**ADDENDUM NO. 2
TO
CONTRACT DOCUMENTS
FOR
655 COOK AVENUE**

DATE: November 1, 2013

ARCHITECTURAL, STRUCTURAL AND SITE SPECIFICATION REVISIONS:

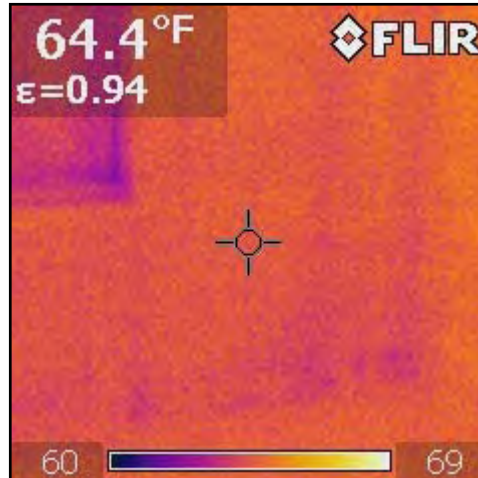
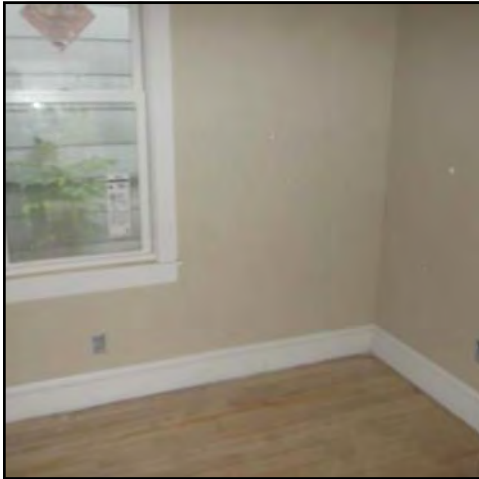
These two images show that the walls have been insulated with sprayed foam insulation.

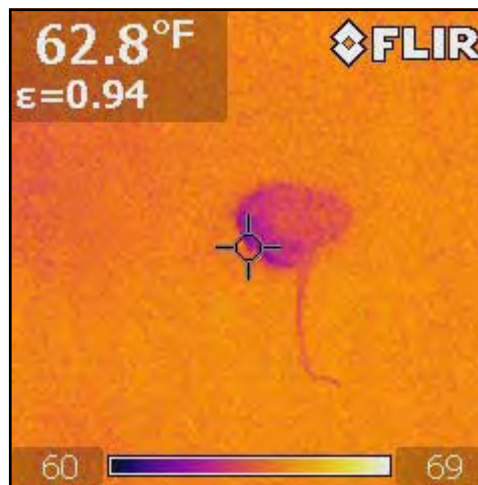
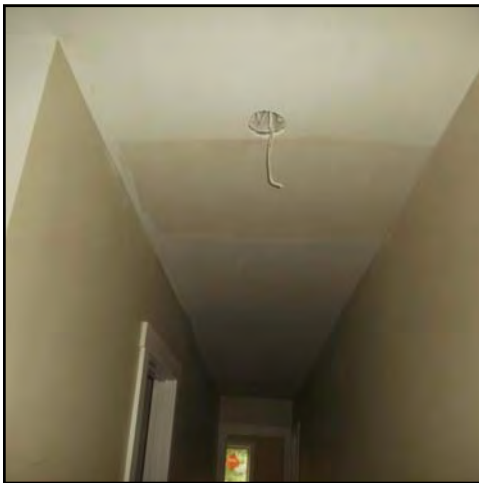
This image is representative of all the exterior walls. While the temperature differential was too small to conclusively say that the walls are fully insulated, this image does show that the studs are cooler than the cavities. This, plus the exposed part of the wall cavities seen on the first two images leads me to conclude that all the walls are insulated.

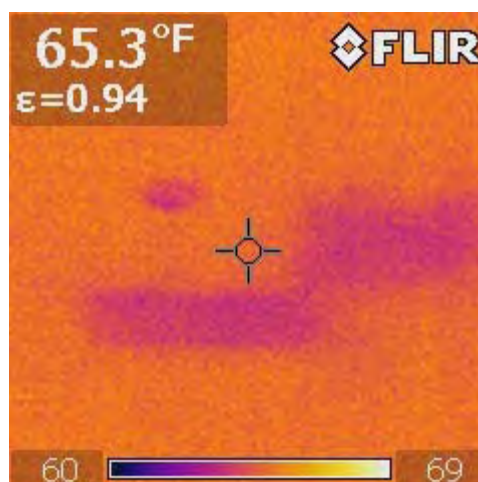
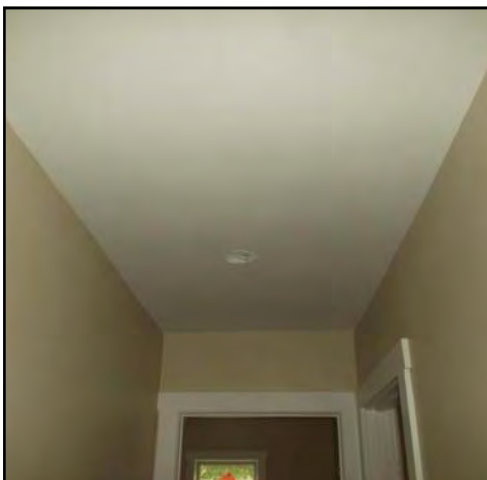
This image of the upstairs hallway shows some air infiltration around the electrical box during the blower door test. This is representative of all the ceiling electrical boxes and it is recommended that they be caulked before the ceiling fixtures are installed.

Second floor bathroom.

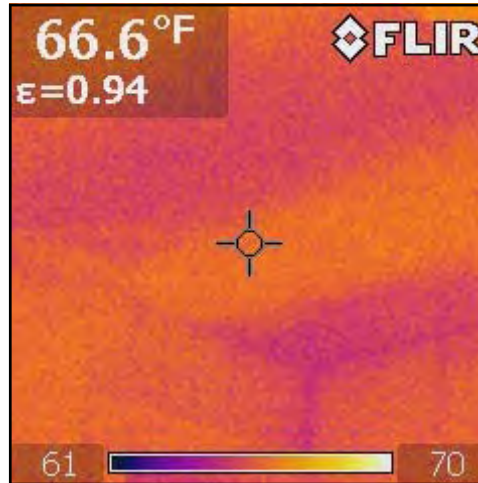
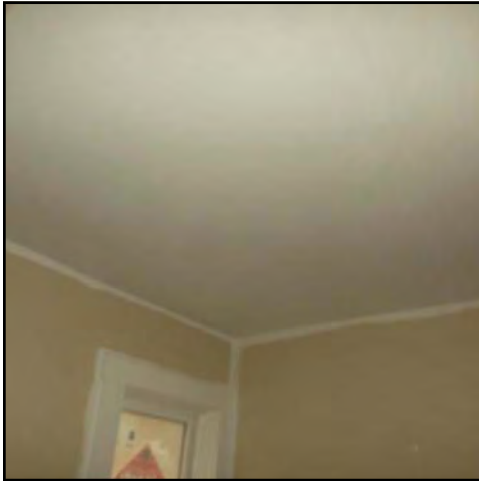
This and the next two infrared images of the second floor hallway and bathroom appear to indicate insulation voids in the attic. There is no access to the attic so these insulation voids could not be verified. The recommendation would be to cut a hole in each area to determine if these areas are small voids or bare areas of the attic floor.

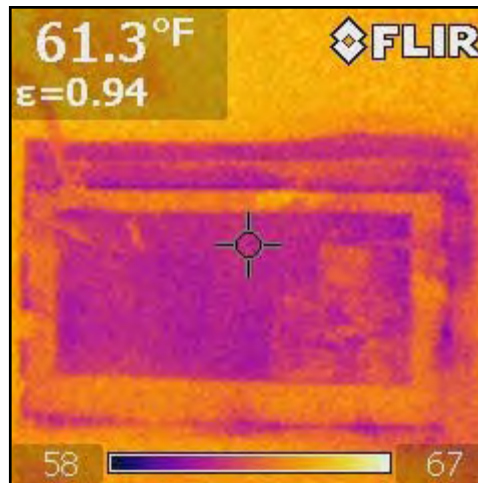
Air leakage in rim joist where the spray foam insulation has shrunk

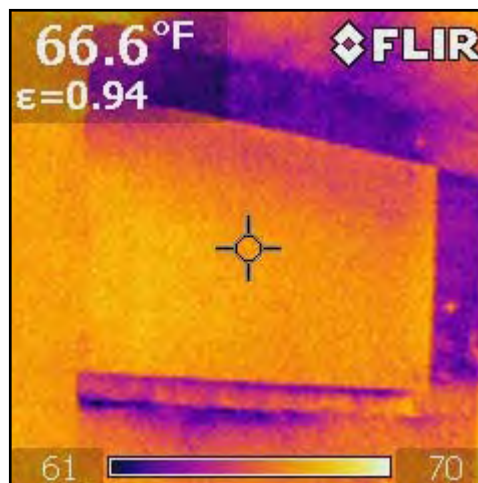
None of the basement windows have been replaced yet and are very leaky.
